Revello Drive and Tramonto Drive Residential Project
ENV-2019-5520-MND

**Analysis of Key Hydrology and
Water Quality Issues
Relative to CEQA**

**Castellammare Mesa Home Owners
Kim Feder, President
April 30, 2024**

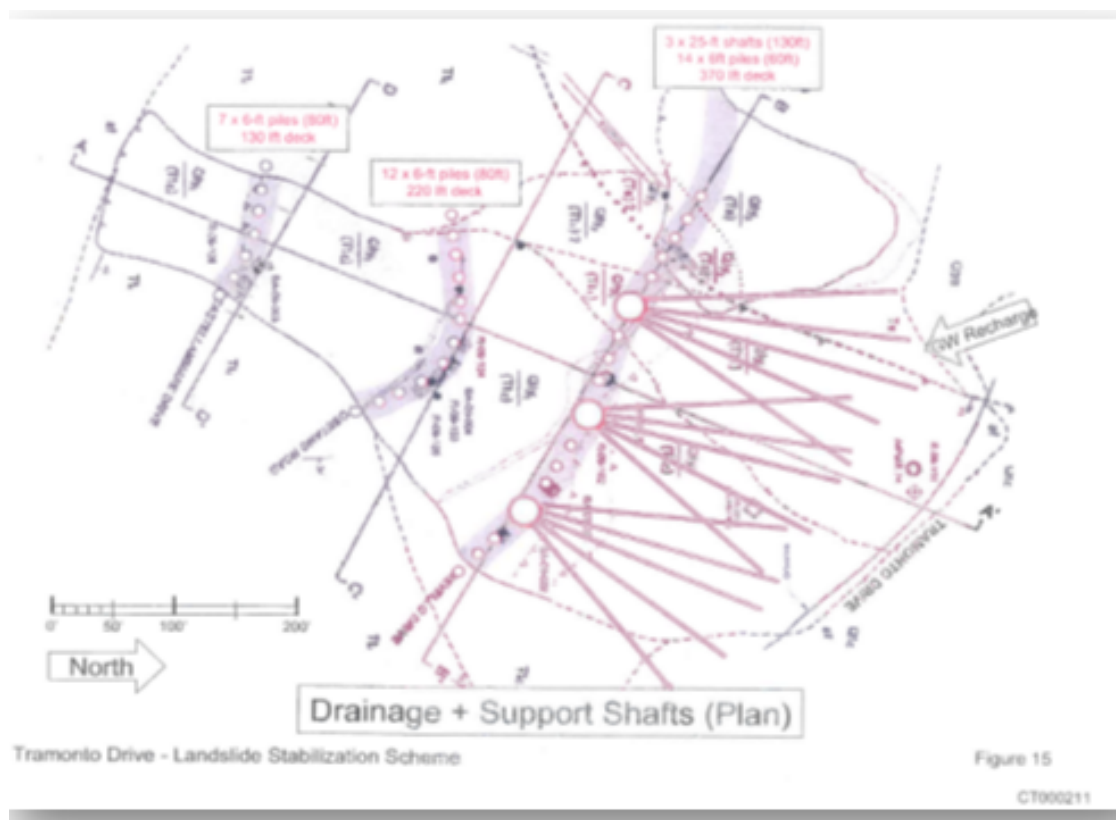
In September of 1957 the sewer in Tramonto Drive was found to be fractured and was replaced with a flexible line, above ground. Maintenance of sewers through slide Location 3 became such a problem during the first months of 1958 that sewers were rerouted downhill, paralleling the Tramonto Landslide.

A perforated drain was placed along Castellammare Drive through the Tramonto Landslide during the fall of 1958 and carried to the Pacific Coast Highway. - *Moran, Proctor, Meuser and Rutledge— July 1959*
